S42A OFFICER'S REPORT FOR:

An application for Resource consent for to undertake a 302-lot fee simple subdivision, 135-lots are for residential dwellings and associated non-compliances with the permitted activity standards and the remainder are to be allocated with the residential lots. Associated earthworks are also proposed totalling 23,940m³ with a maximum depth of 4.4m. A private road is proposed to serve the dwellings with the main access from Halsey Grove at 240 Kapiti Road, Paraparaumu.

Sarah Banks
Principal Resource Consents Planner
Kāpiti Coast District Council

18 October 2022

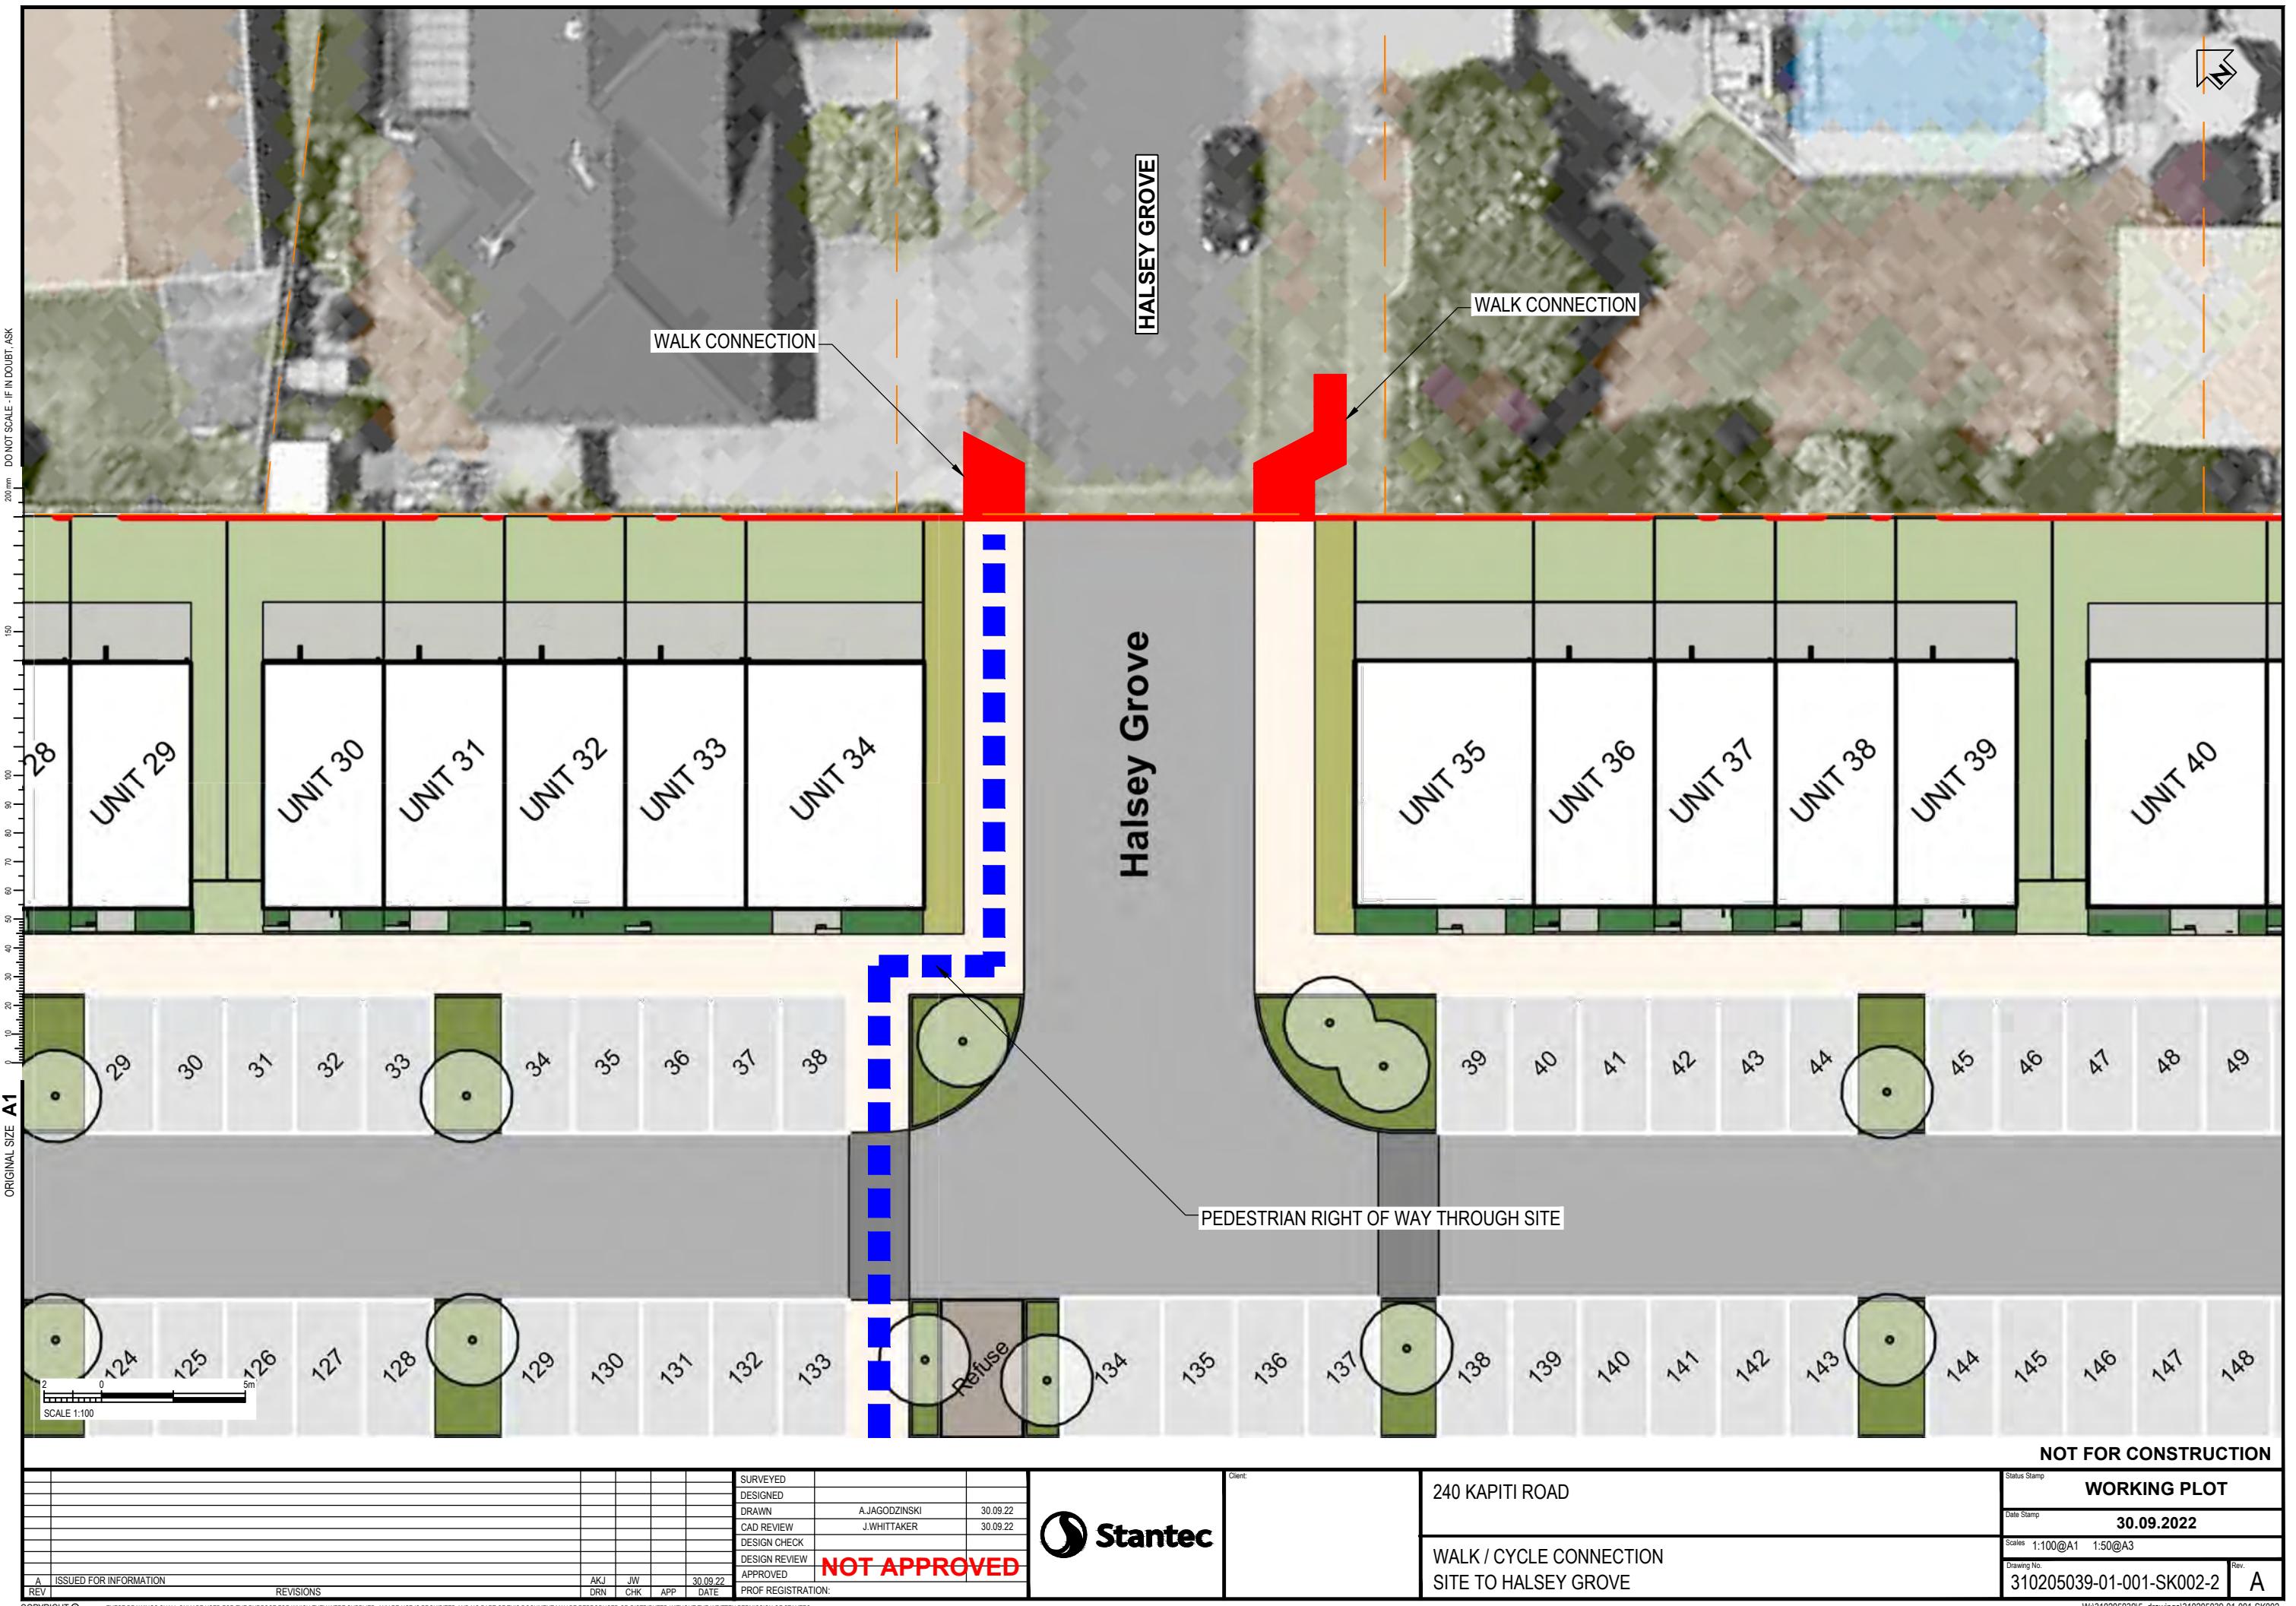
- 105) *Drawing 22930 SCH1 Sheet 16 Rev A shows proposed Finished Floor Levels (FFLs) ranging from 5.7mRL adjacent to Halsey Grove to 6.6mRL adjacent to Kāpiti Road. Kerb level on Kāpiti Road is stated to be around 6mRL however KCDC LiDAR survey indicates crown levels up to 6.5mRL on Kāpiti Road – i.e., less than 150mm below the proposed FFL. Recommend that further information is provided to confirm that proposed FFLs are above the 1% AEP water levels along overland flow paths within the site (including climate change allowance) and will also meet Building Code requirements in relation to crown of road outside the site.*
- 106) *Based on the above assessment conditions have been included within the recommendation to address all of these matters. Based on the expert reports provided with the application, I consider the adverse natural hazard effects to be less than minor.*

Drawing 22930 SCH1 Sheet 16 Rev A shows proposed Finished Floor Levels (FFLs) ranging from 5.7mRL adjacent to Halsey Grove to 6.6mRL adjacent to Kāpiti Road. Kerb level on Kāpiti Road is stated to be around 6mRL however KCDC LiDAR survey indicates crown levels up to 6.5mRL on Kāpiti Road – i.e., less than 150mm below the proposed FFL.
